ECE/TRANS/WP.29/GRSP/2009/3
6 March 2009

GLOBAL TECHNICAL REGULATION No. 9
(Pedestrian safety)

Proposal for draft amendments

Draft corrigendum to the global technical regulation

Paragraph 6.3.1.1.7.2., figure 12, replace by the following:

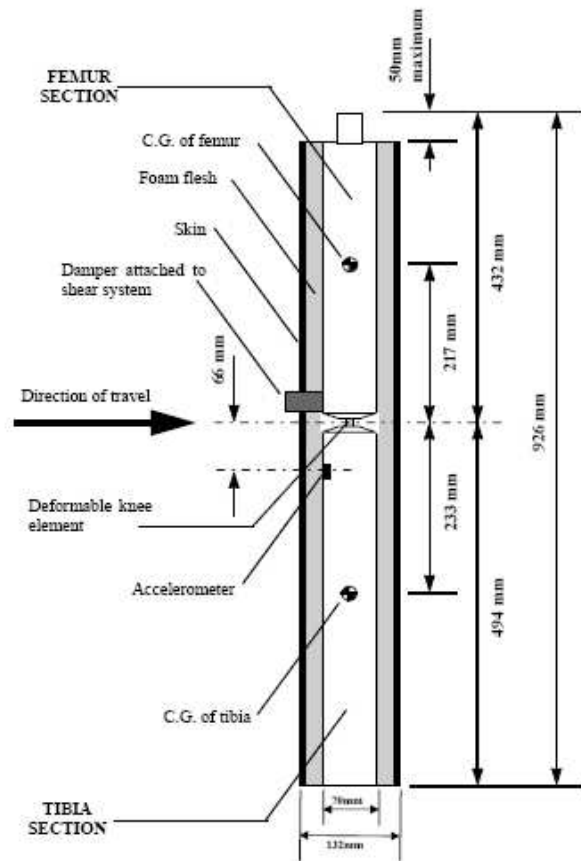
"6.3.1.1. ... test mass of 13.4 ± 0.2 kg (see Figure 12). **Dimensions of the various parts are detailed in Figure 12.**"

Figure 12: The existing figure 12 is not complete, since it does not show the overall diameter of 132 mm.
